**Addendum 1**  
**Solicitation 23-99029**  
**RFP for Engineering Svcs for Irving Park Bio-Filtration Basin**

**APPENDIX B – LOCALIZED PROJECT LOCATION – IRVING PARK  
CITY OF DULUTH  
RFP# 23-99029**

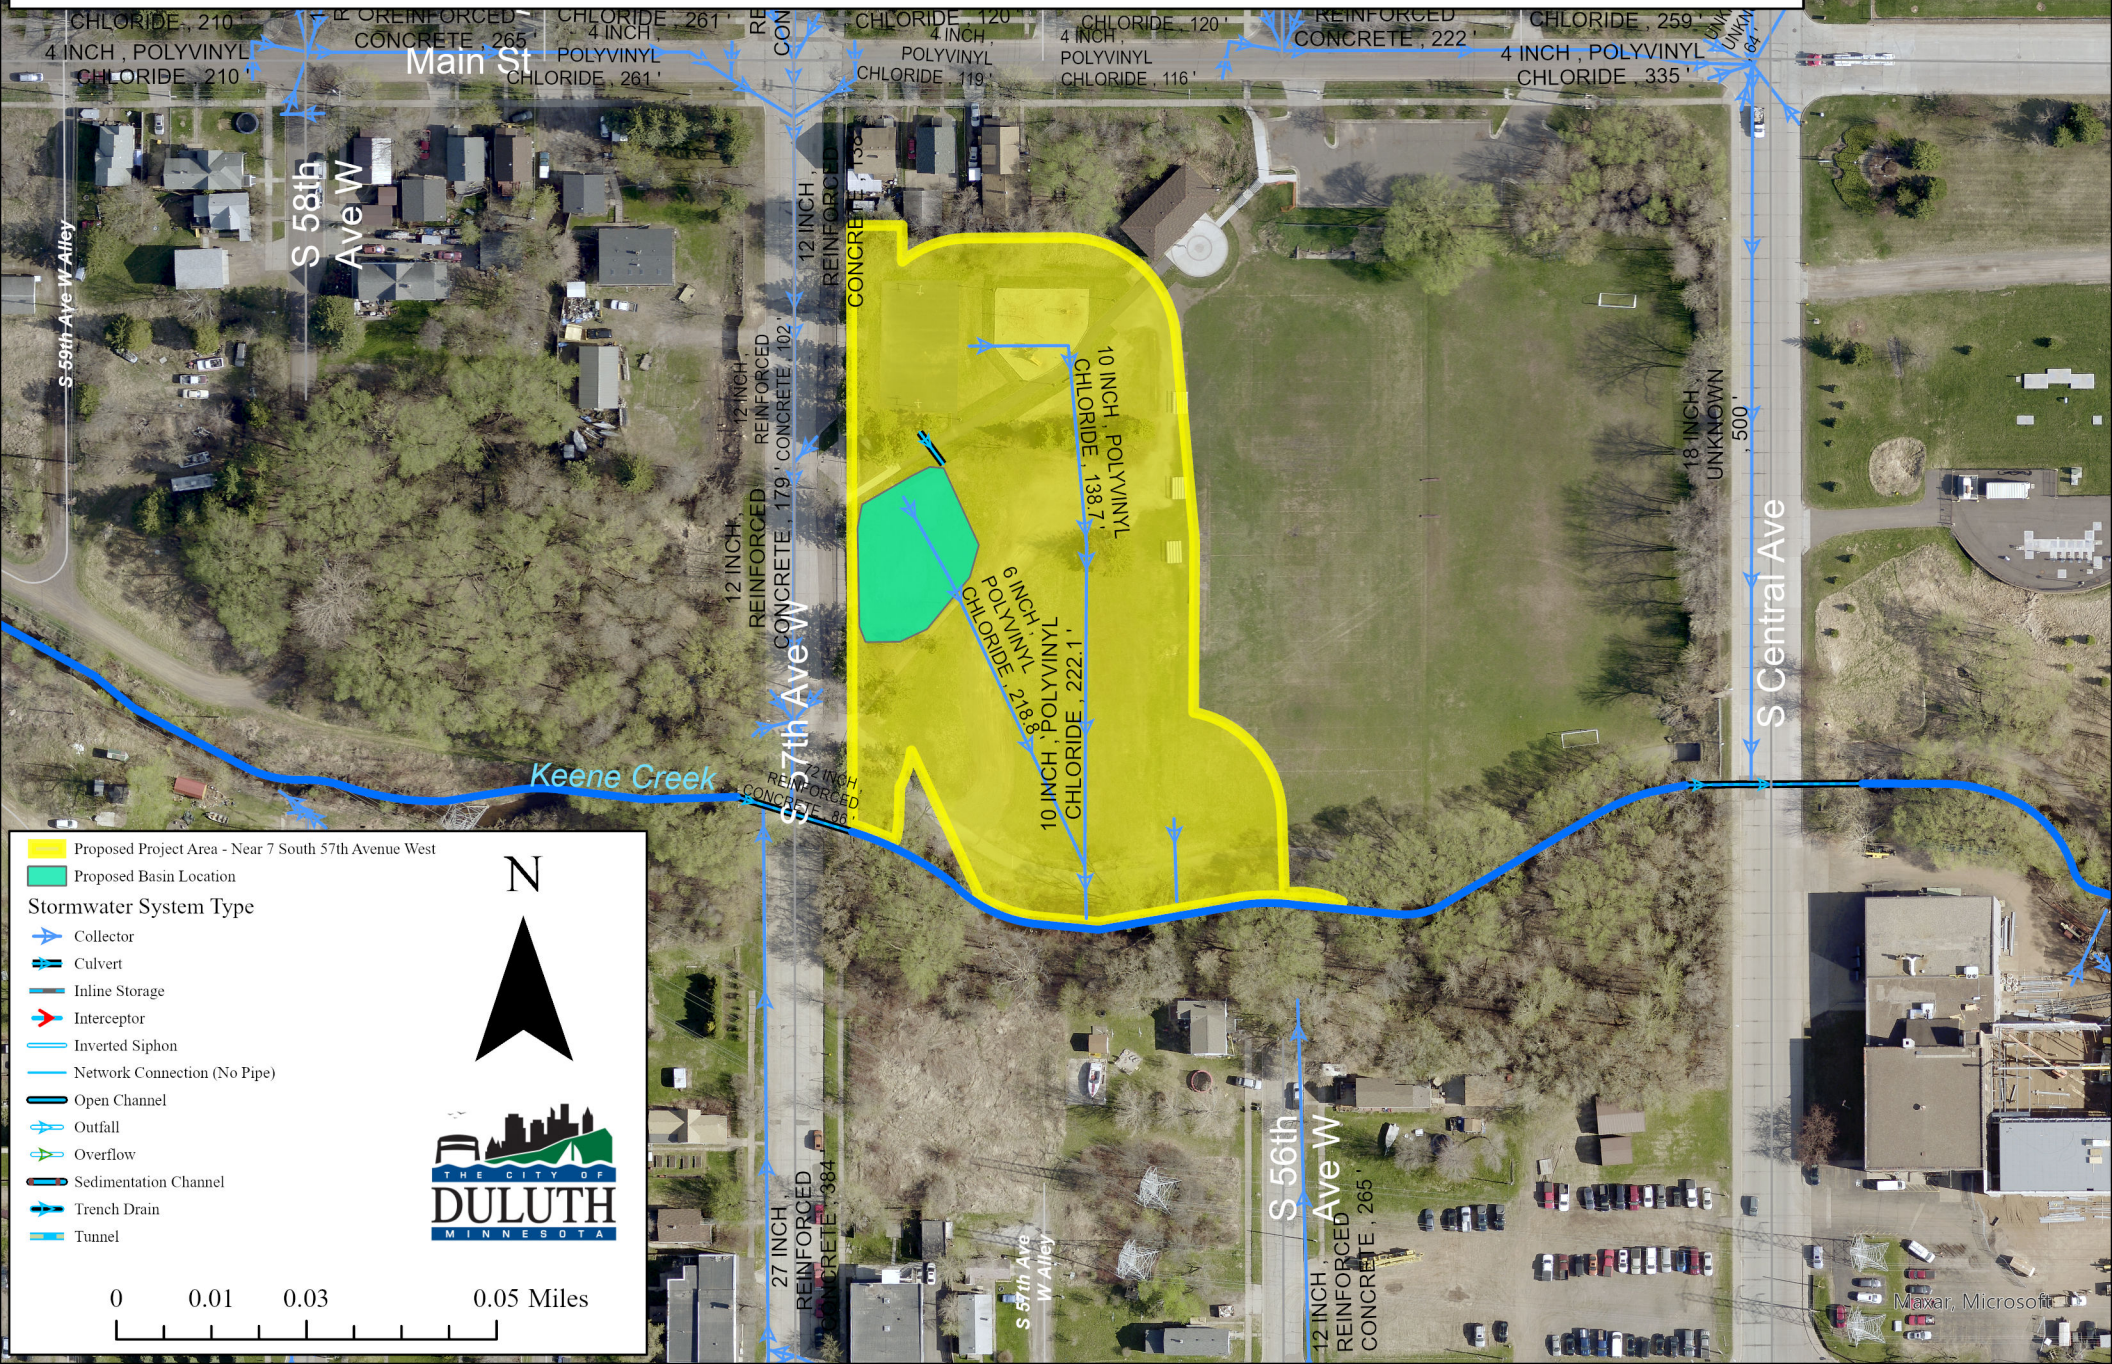
Attached is a revised Appendix B, *Localized Project Location – Irving Park*, which includes a concept drawing of the area.

If next down gradient manhole is not shallow enough, then this is next option, considerable more pipe and restoration costs.

Forebay, pretreatment to protect filtration basin, collect sediment and trash. Provide perimeter berm 8" high to provide capture of pollutants.

Determine the manhole depth, can it be diverted to GI. Survey required.

Provide 4" perforated subdrains grid and header as shown. Connect to existing inlet.

Saw cut and remove concrete and restore to match existing road section.

Excavate entire area 24" deep except forebay area, till bottom of basin - native soils to 12" depth, grade to provide flat bottom. Install 12" depth of clean rock, place perf pipe 4" off of bottom of native soils. Cover perf pipe with 4" depth of rock on top of pipe. Raingarden filtration / planting soil mix 12" depth. Provide seed mix and ECB.

Install 70 l.f. of 10" Dia. CPP, match invert of manhole with diverter plate. Extend to GI.

Provide berm on south and east side to provide runoff storage, and to keep water from entering park area. Berm to be 18" higher than basin elevation.
